THE MARYLAND-NATIONAL CAPITAL PARK AND PLANNING COMMISSION

MEMORANDUM

REVIEW TYPE: Site Plan Review, Preliminary Plan Amendment
APPLYING FOR: Approval of 58,170 gsf office use on 1.941 acres
PROJECT NAME: North Germantown Parcel H
CASE #: 8-02012, #1-02040
REVIEW BASIS: Sec. 50, Sec. 59-D-3, M. C. Code

PROJECT DESCRIPTION: Proposal

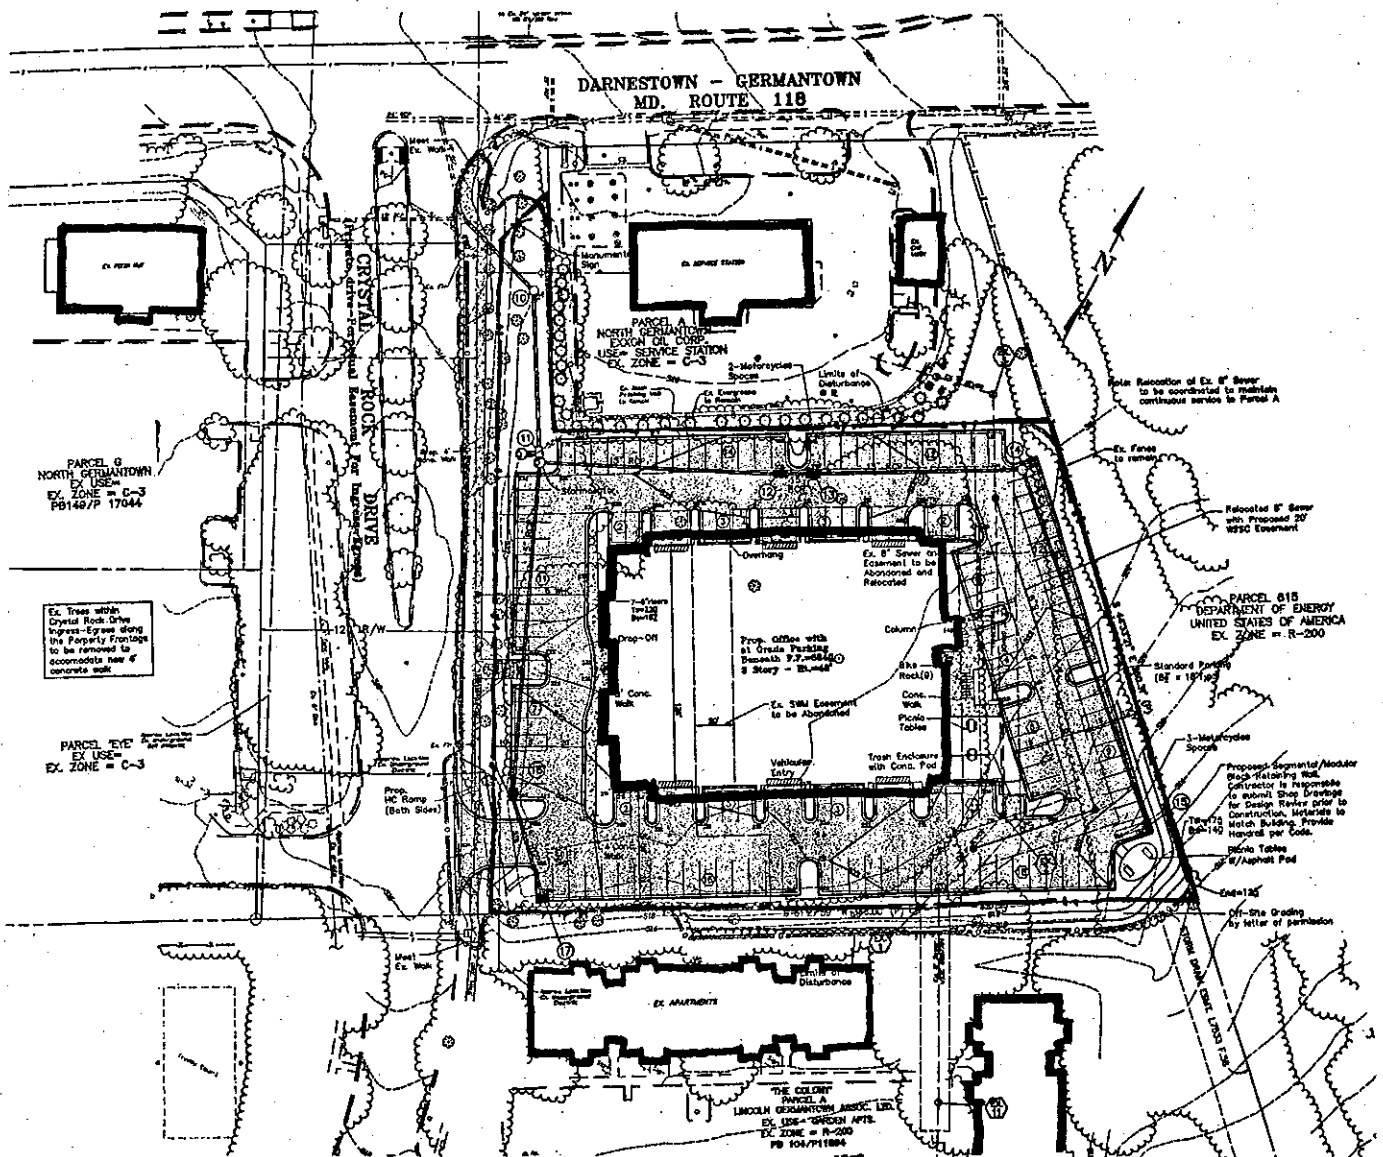
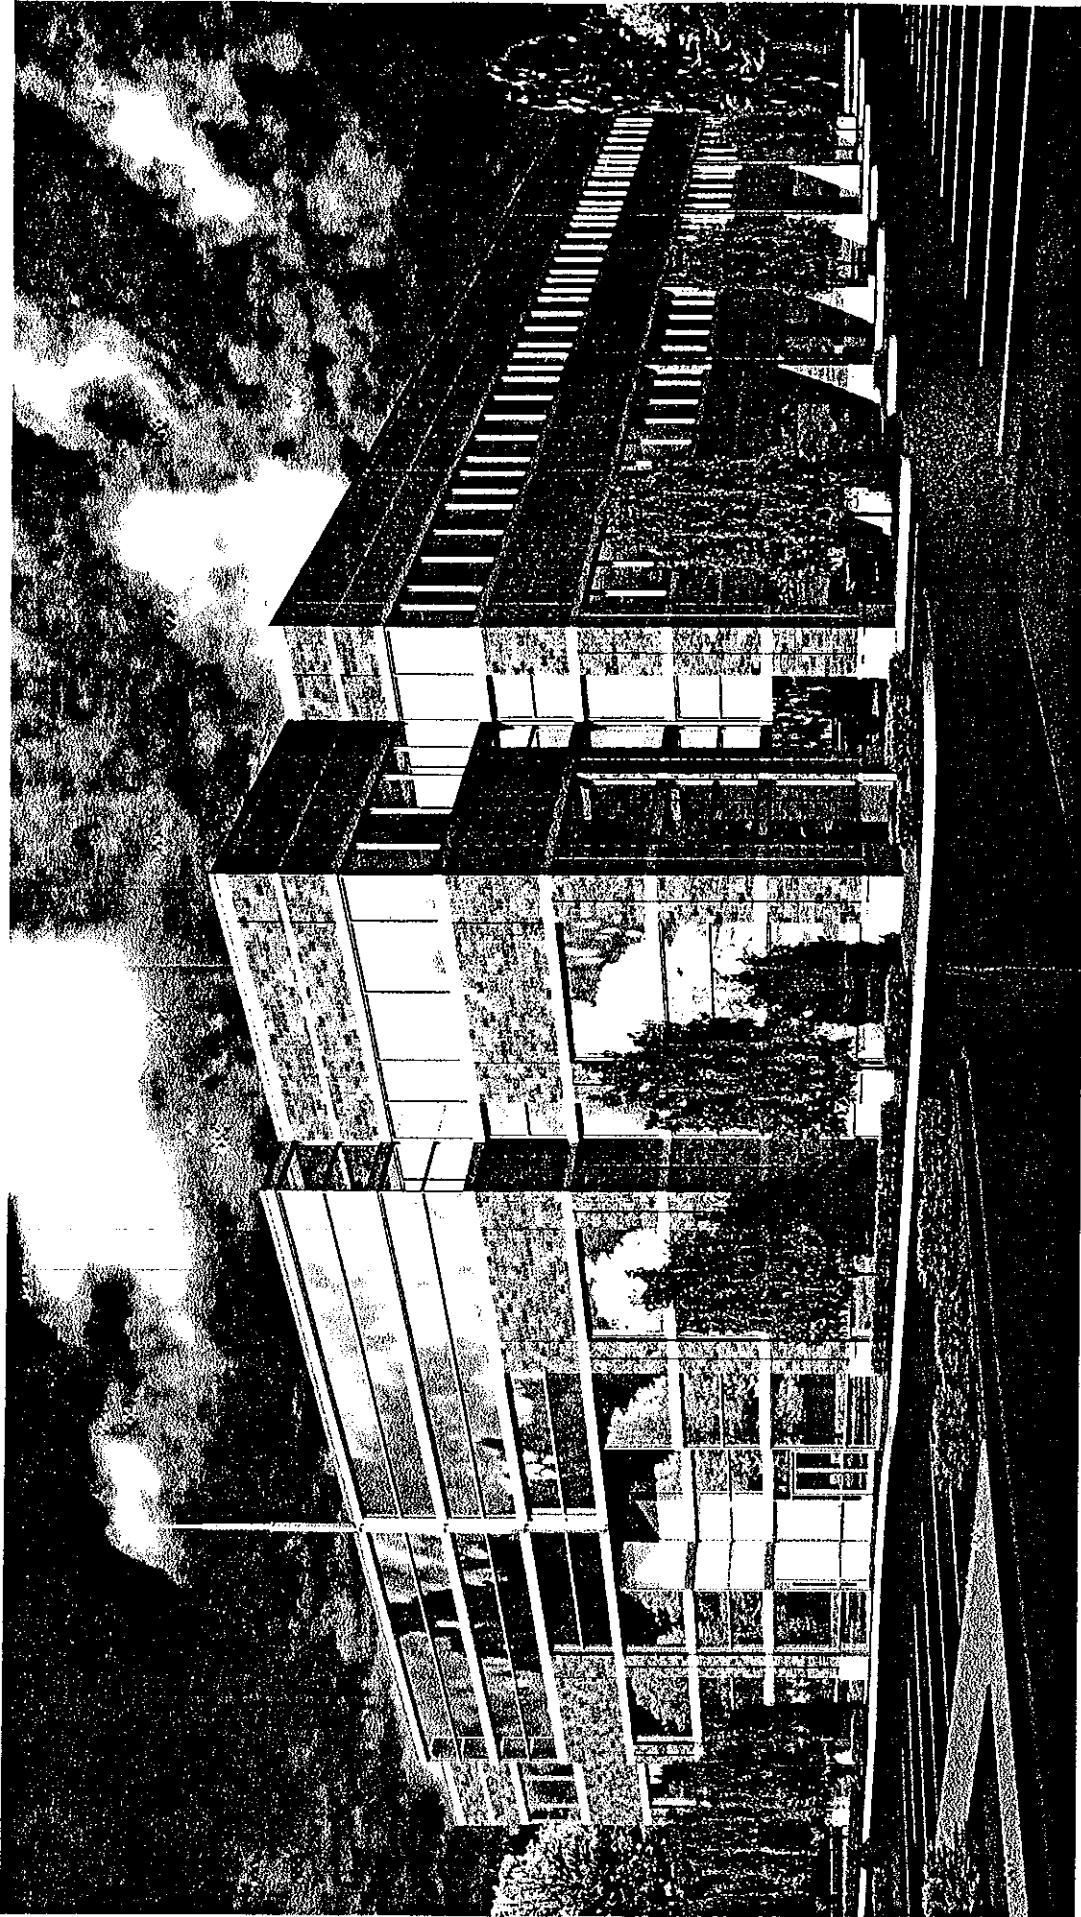
The three-story building is situated in the middle of its site and surrounded by its 199 parking spaces, which also extend under most of the building on the ground floor. Except for the front edge of the ground floor, which encloses lobby and office space, the office space is all above grade. By condition of this approval, the Norway Maples are to be preserved to balance the look of the other side of the private street. The White Pines are to be removed in favor of new landscaping more in character with the office use and to afford the proposed building some visibility from the street and MD #118.

The buffer along the Colony apartment property line is to be reinforced with more landscaping to replace that lost due to maturation of the existing White Pines. A six foot hedge is proposed, to hide the parking from the apartments, which are at a lower elevation.
